Front Service Washer Updates

GE Appliances

HOME LAUNDRY HL3-96
LOUISVILLE BUILT "T" MODEL-
HOTPOINT, GE, RCA WASHERS.
LOWER HARNESS KIT

LOWER HARNESS KIT FOR "T" MODEL WASHERS WH49X0302

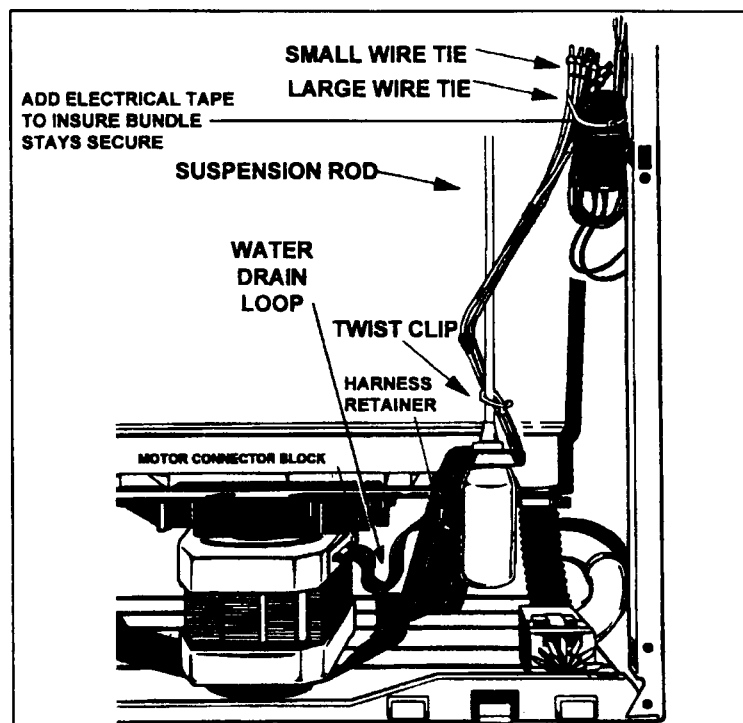
1. Unplug washer.
2. Remove front panel.
3. Cut all the wires in the wiring harness to the motor, at the bottom of the steel suspension rod. Strip 7/16" insulation from all 7 wires coming from the top of the cabinet. Excess wire will be looped at the side of the cabinet later on in the installation.
4. Unplug remaining harness at motor and discard.

- IMPORTANT!** 1. Find plastic push in harness retainer on new harness section and insert it fully into existing hole in right front *platform leg*. (See illustration for location).
- IMPORTANT!** 2. Plug in motor connector until it is seated, and make sure that the harness forms a loop below the motor connector to prevent water from running down wires and into motor plug.

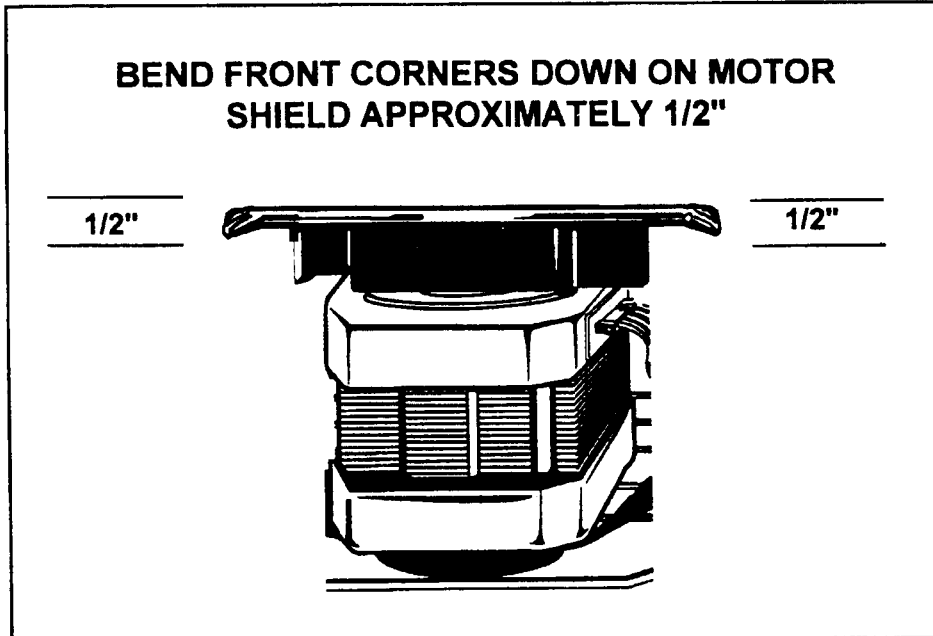
3. **ROUTE WIRES BEHIND FRONT PLATFORM LEG.** Dress wires upward spiraling between tub and suspension rod, towards capacitor mounted on cabinet flange. (See illustration)

4. Match color for color wires in harness and twist them together. Install closed end splice connectors and firmly crimp all 7. (Crimp with standard crimping tool).

5. Using small wire tie, secure all 14 wires together just below connectors.
6. Position the wire bundle directly behind the capacitor with the wire connectors protruding 2 1/2" above the capacitor top. Secure with the large wire tie to the capacitor. (See illustration)

7. In addition to wire tie, use black electrical tape to secure wire bundle to top of capacitor, to insure that bundle is secure. (**NOTE:** this is easily done if capacitor is removed from cabinet side, taped and then replaced.)

8. Install plastic twist clip to secure new harness to suspension rod.
- IMPORTANT!** 9. Bend down both right and left corners of the galvanized drip plate downward about 1/2" to insure proper water drainage away from the motor and motor plug.

BEND CORNERS OF MOTOR SHIELD DOWN ABOUT 1/2"

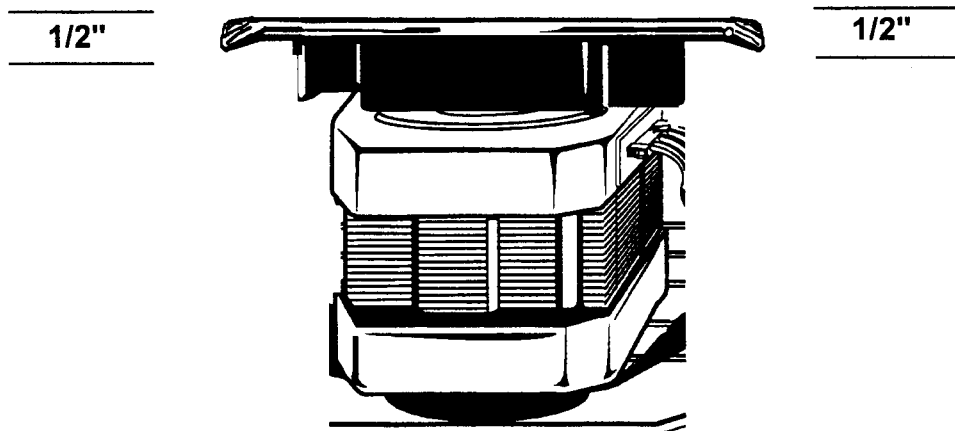
On some full sized GE, Hotpoint, RCA, and Profile washers the hose on the bleach funnel to the air vent bottle can be kinked when installed at the factory. To eliminate the kink, remove the front panel from the machine, disconnect the hose from the funnel, cut off approximately 1/2" of the hose, reposition the air vent bottle and the hose to eliminate the kink. Caution the customer to only pour bleach into the funnel as fast as the system will allow. Do not pour fast enough to cause the funnel to overflow. Before reinstalling the front panel, bend the outside corners of the motor shield down 1/2" according to illustration below.

**WH46X0360
FOAM INSULATOR**

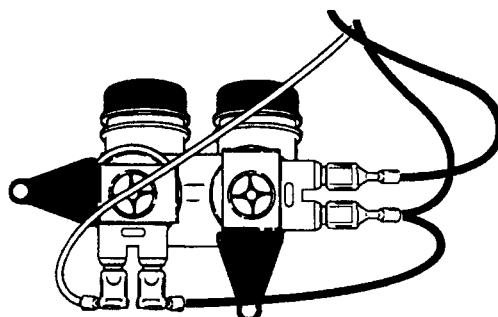
To address customer complaints of water valve noise or "squealing, on non-Profile models, replace water valve, and add foam insulator now available from parts (WH46X0360).

**FOLD INTO "L" SHAPE
WITH WATER VALVE
INLET HOLE IN THE BACK,
PLACE LOWER PORTION
INTO INDENT IN WATER
VALVE BRACKET
AND SEAT**

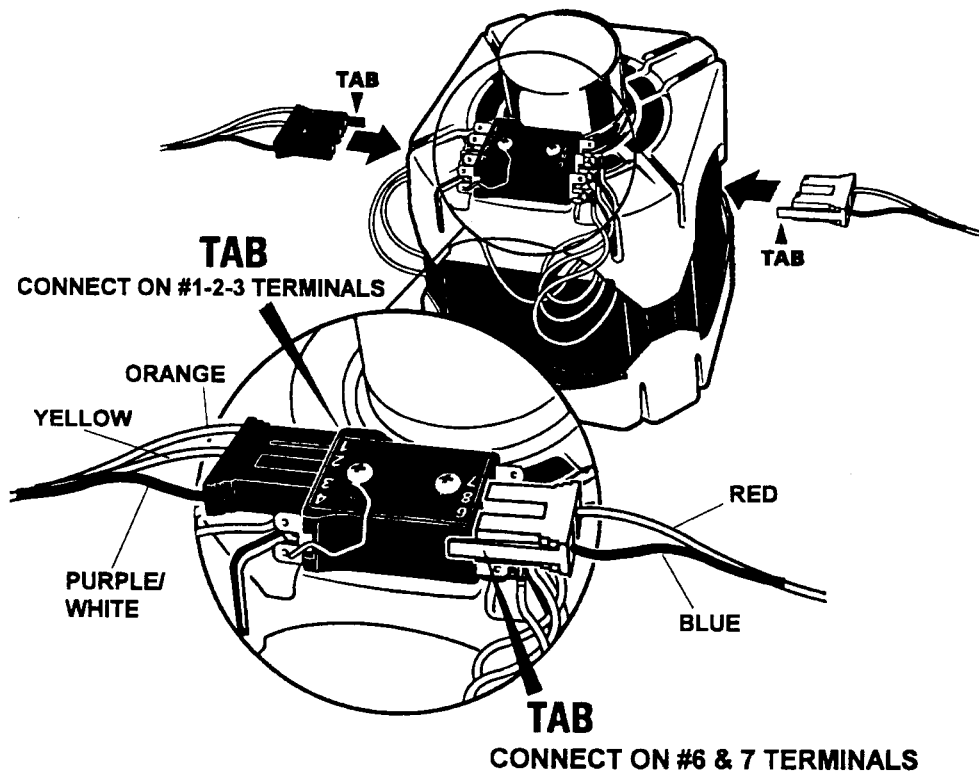
When replacing a single speed "T" model washer motor (WH20X865), the number terminal code on the harness connector block will not match the numbers on the new replacement motor.

2. Ignore the stamped number code on the new motor connector, and instead match the harness blocks by color.
3. See illustration below for correct wiring connections for the new K-Stack motor.

BLEACH DISPENSER KIT WH49X314

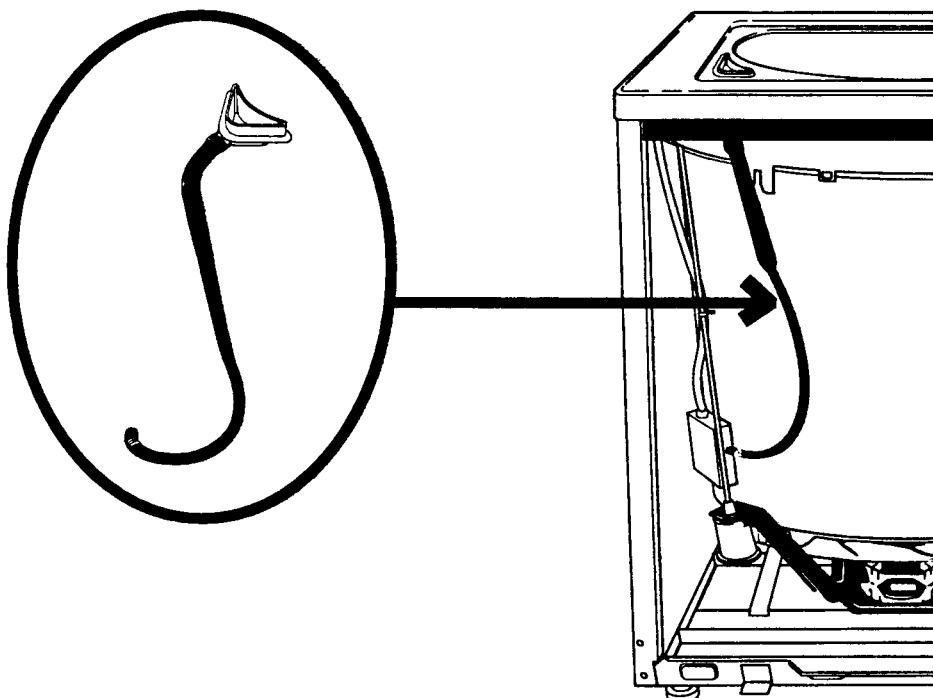
On all "T" model Profile, GE, Hotpoint, and RCA washers, the bleach dispensing system has been changed and simplified. The new system consists of only three parts, does not kink, and allows more bleach to flow through the system. This reduces the chance of a customer overfilling and damaging the machine. The new bleach dispenser is available as a kit, Part # **WH49X314**, and will fit all "T" model washers having the bleach dispenser option.

To use the new bleach dispenser system on existing machines remove all of the parts associated with the old system and discard. Install the kit by raising the washer cover, snapping the funnel into the existing hole, and threading the hose down through the rod support. The clamp provided is to seal the connection at the tub. This clamp must be disconnected when removing the cover in the future.

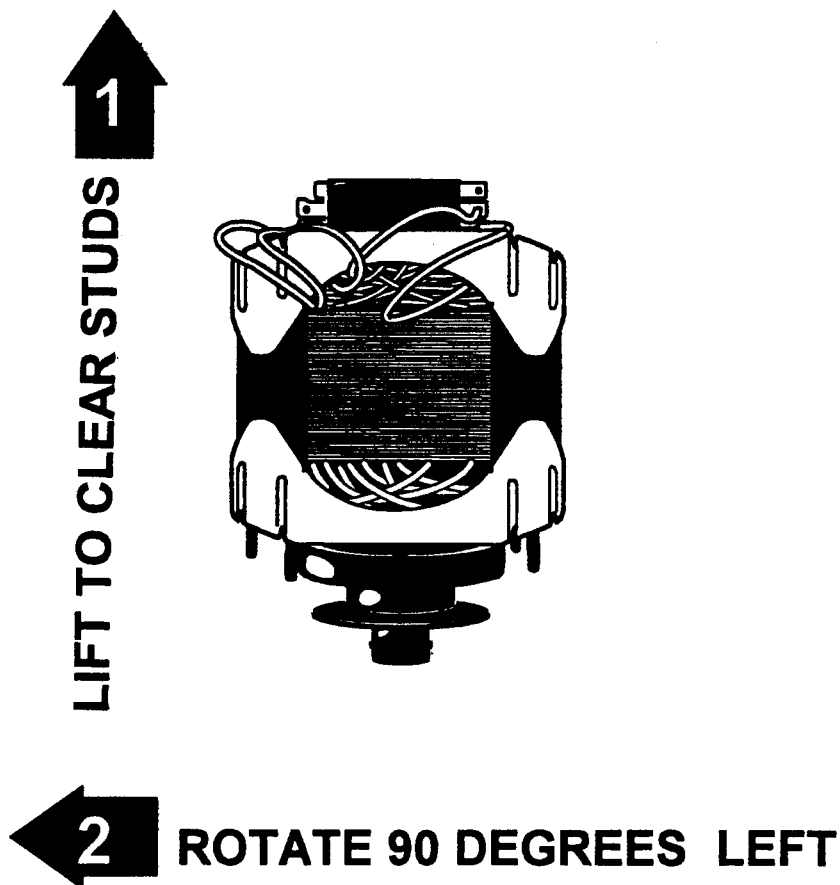
On all "T" model GE, Hotpoint, and RCA washers, the single speed motor stack height was increased, making it necessary to change the motor removal procedure.

If the motor won't tip to the back after you remove the four attaching nuts, the harness, and the belt, lift it enough to clear the studs and rotate it 90 degrees to the left. That will allow the centrifugal switch to clear the motor shield and allow the the motor to be tipped back and pulled foward, clear of the machine.

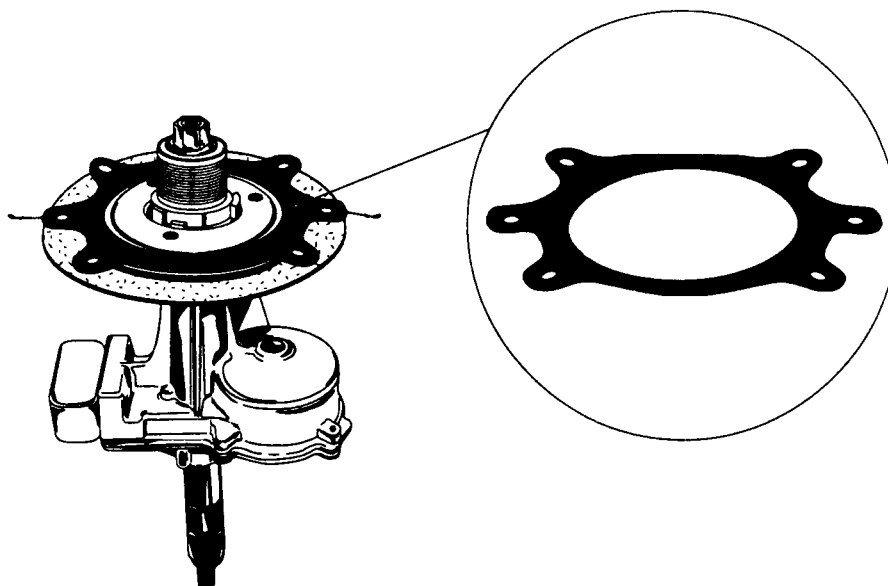
Customer complaints of transmission noise, oil leaks, or being locked up on GE, Hotpoint, and RCA full-sized washers can be solved using a transmission with a newly designed brake system. The transmission part number is WH38X10002.

The design change to the new transmission involved having manufacturing move the brake friction material from the bonded rotating plate. In the new design, the brake material is bolted in place to the platform.

WH45X10022

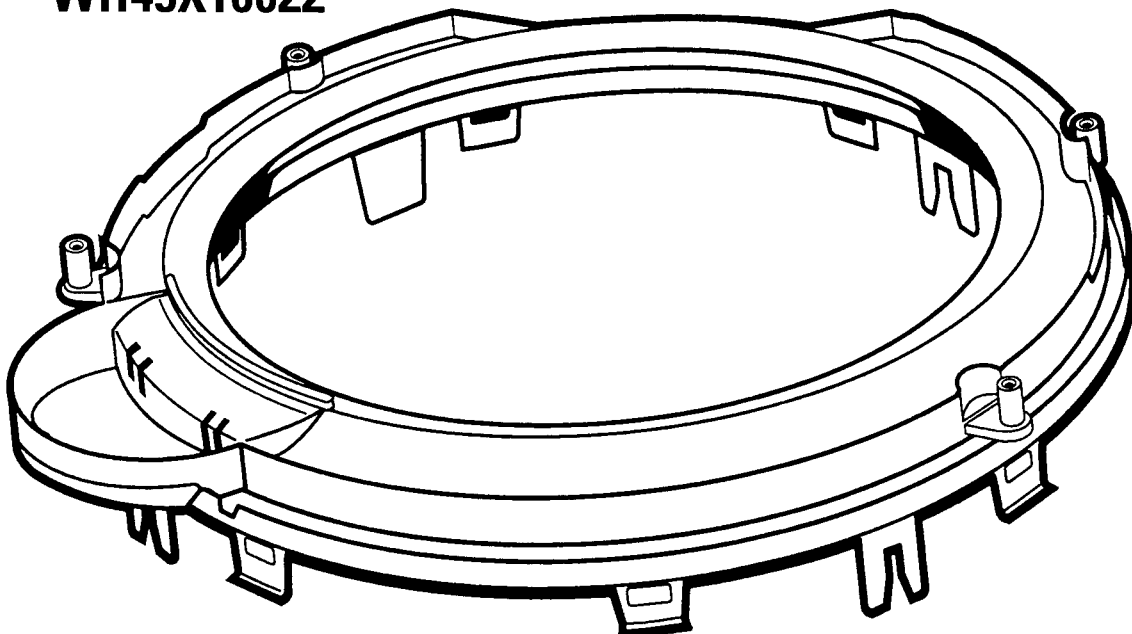
Effective May 1st 1998, the factory will start producing washers with a new redesigned Tub Cover with a new Bleach system. The part number for the new tub cover is WH45X10022.

If it becomes necessary to replace a tub cover on a washer with the old tub cover and the bleach dispenser system that connects to the tub chamber, you will need to order a WH49X10010 Tub Cover Kit. The Kit includes a new tub cover, bleach funnel, wire tie, cap, clamp, and instructions. When using the kit you must discard the old bleach asm. components.

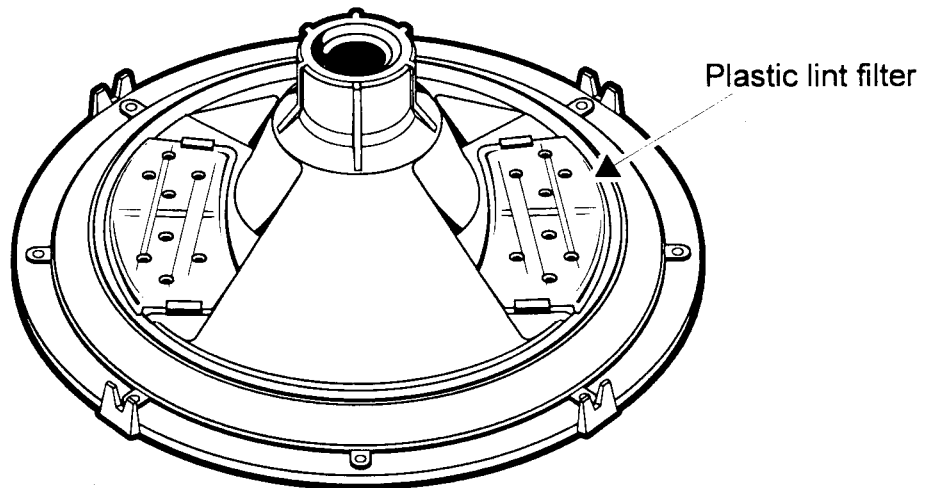
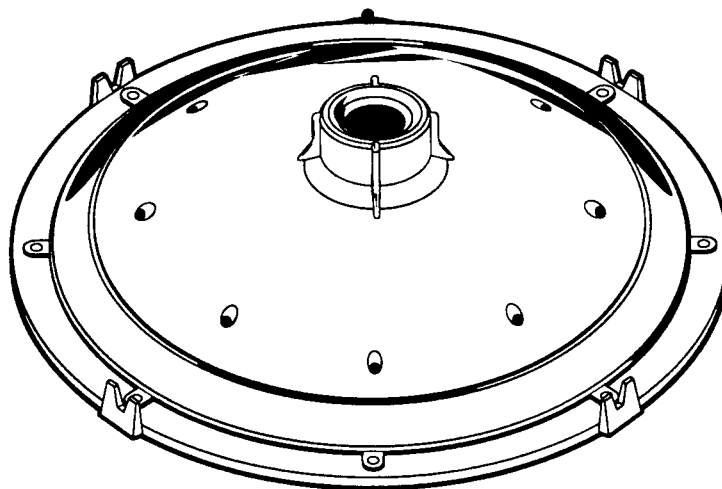
Effective October 1, 1998, all Louisville built GE washers are being produced with a one-piece lint filtering hub (WH45X10027). This change eliminates the need for plastic lint filters on all Louisville built washers produced after October 1. The plastic lint filter (WH1X2728) will remain in inventory as a replacement part for units manufactured before October 1, 1998.

Figure 1

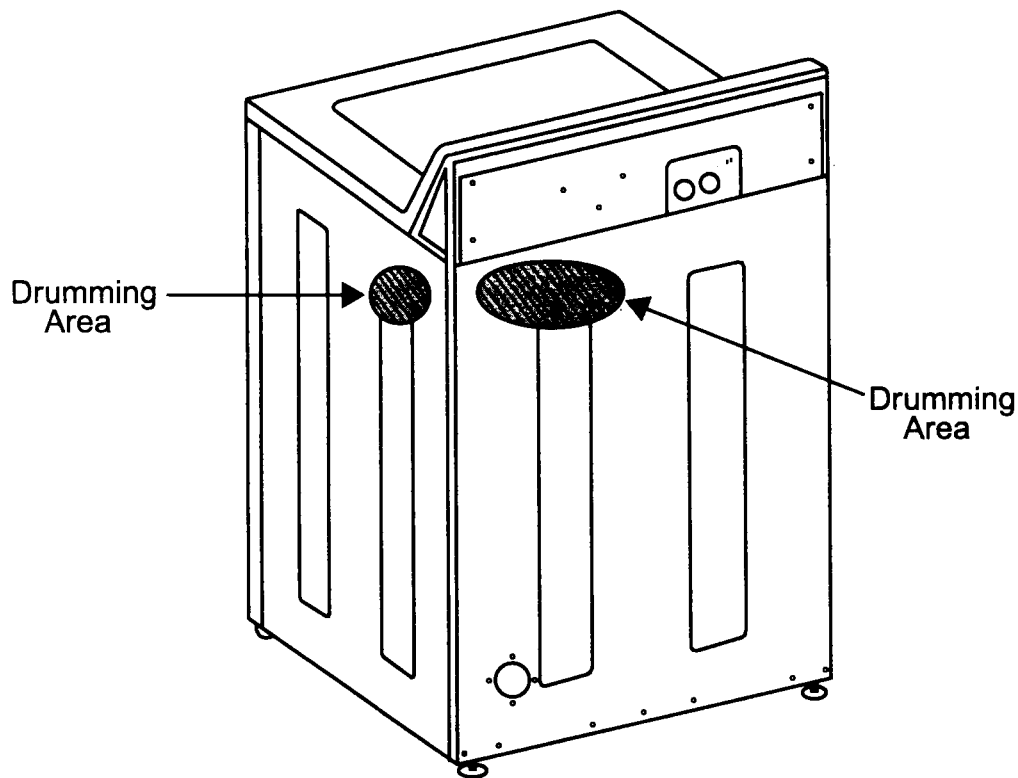
Cabinet drumming is the flexing of the side of the cabinet during agitate. It becomes worse as the amount of clothes in the washer is increased. A small area on the right side of the apron near the top rear OR on the back side near the top right will pop in and out. See the identified areas in Figure 1.

Figure 2 - cross section

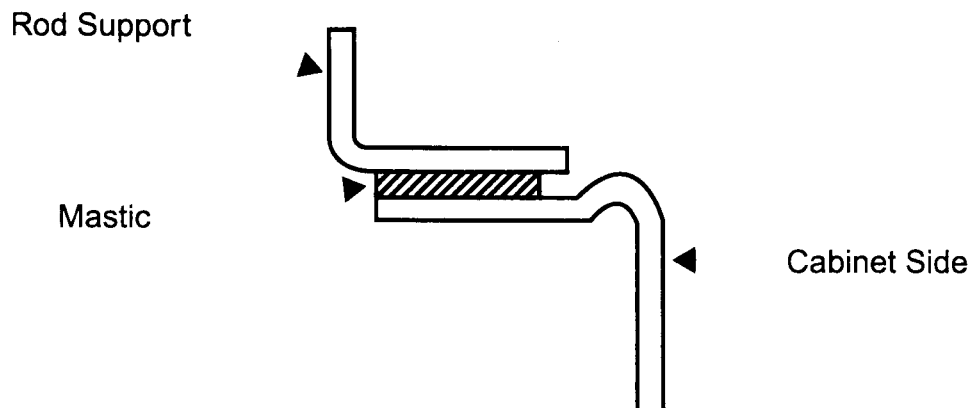
Add a small piece of mastic (single or double thickness) between the rod support and apron flange directly above the drumming point. See Figure 2.

Figure 1

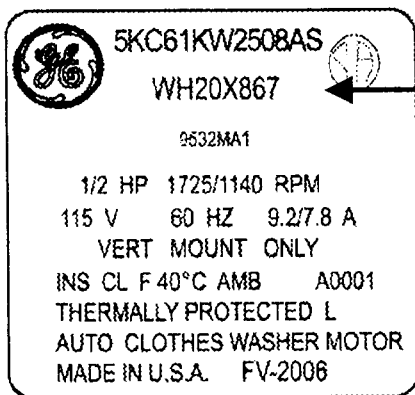
When replacing a capacitor start washer motor, either the WH20X867 or WH20X10006 series motors is acceptable. For washers without a capacitor, only use the WH20X10006 motor. The WH20X867 motor when installed without the capacitor does not have sufficient torque in low voltage situations.

Motors with this model number can be used on washers with and without capacitors.

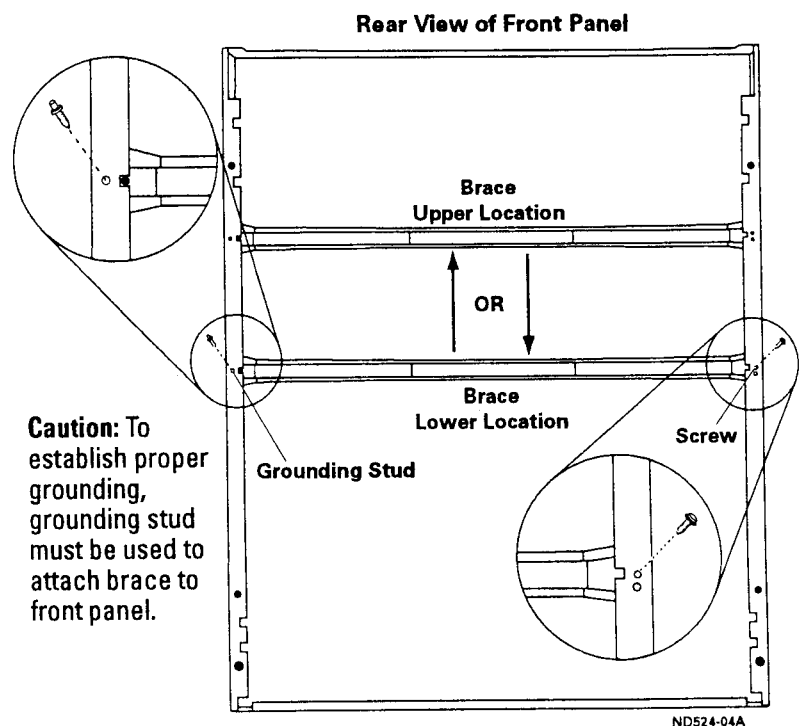
As a result of manufacturing changes and increasing concern with the possibility of improper installation, GE has developed an assembly kit (WH49X10021) to be used when replacing the front panel. The use of this assembly kit is necessary to ensure the proper installation of all replacement front panels. Improper installation issues such as, failing to install the brace or attaching the brace to the panel without the use of the grounding stud, may result in poor product performance and/or electrical shock. The kit, when used properly, will eliminate these concerns.

1. Remove existing front panel.
2. Determine correct brace location by examining existing front panel or machine's apron for previous brace location (upper or lower location). After correct brace location has been determined, discard old front panel.
Note: If wrong location is used, front panel will not assemble to machine apron.
3. Locate identifying mark (X) on the end of brace, just above screw hole. This end of the brace must be attached to front panel using the screw. The opposite end of the brace must be attached to the front panel using grounding stud. (Refer to front panel diagram, and attach exactly as shown).
4. Attach replacement front panel to machine.
